ADDENDUM NO. 3
TO
CONTRACT DOCUMENTS AND SPECIFICATIONS
FOR
LINCOLN WASTEWATER SYSTEM
NORTH 31ST STREET – DEADMANS RUN EMERGENCY BANK STABILIZATION

Specification No. 07-227
HDR Project No. 12595
City Project No. 502009

DATE OF ISSUE: August 22, 2007

HORIZONTAL AND VERTICAL CONTROL

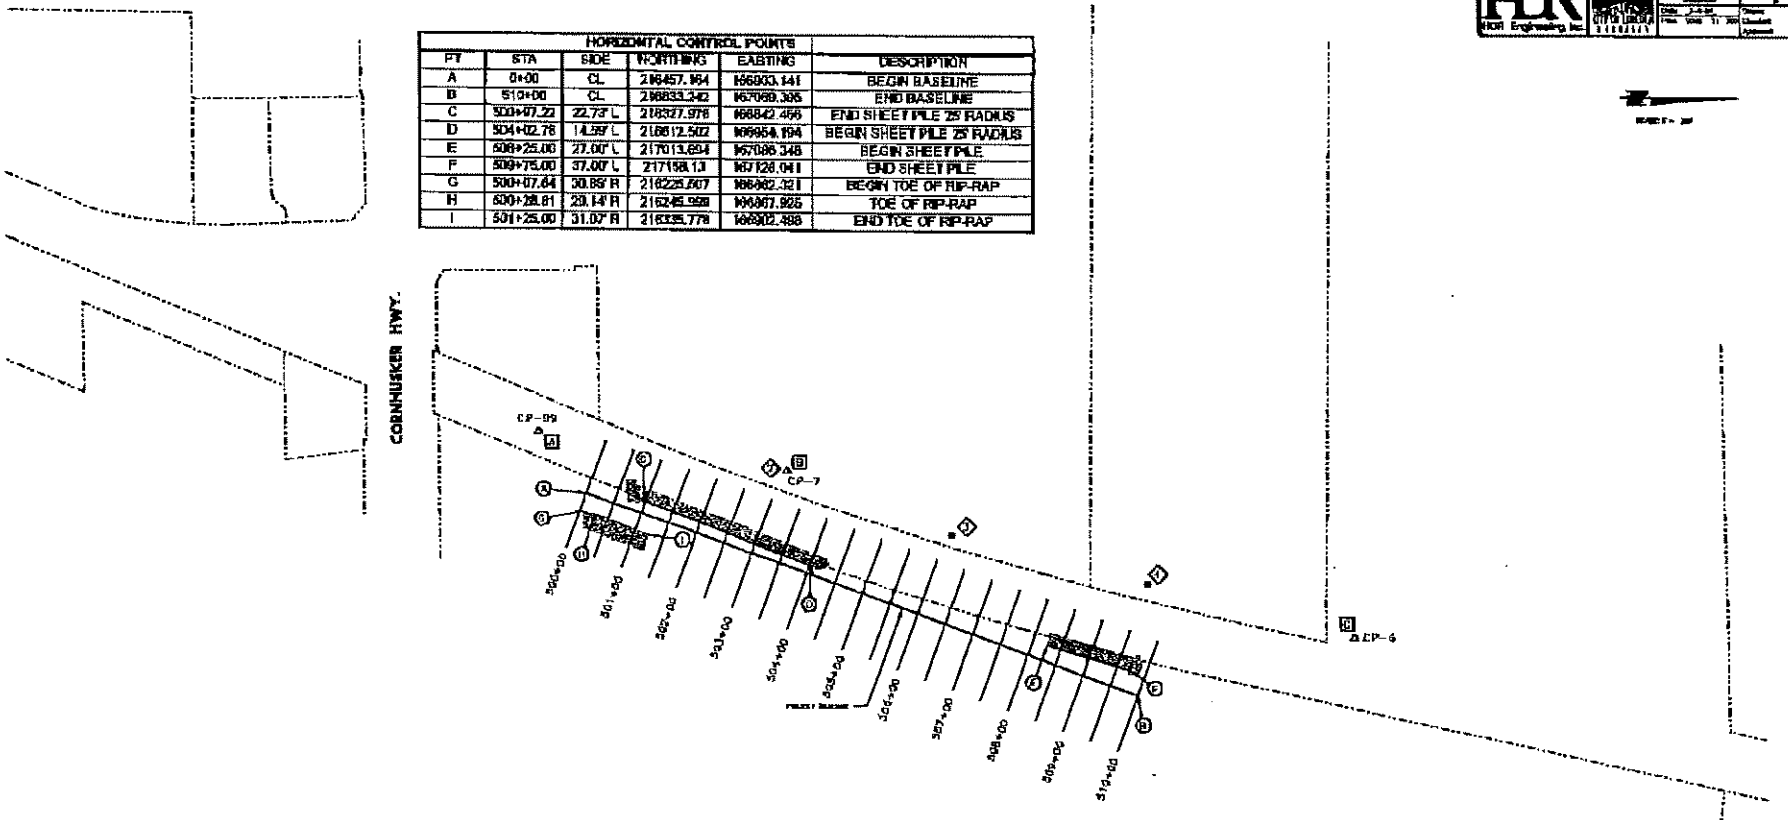
1. DELETE Drawing Sheet No. 8 from the Issued for Bids plan set and INSERT the attached revised Drawing Sheet No. 8.
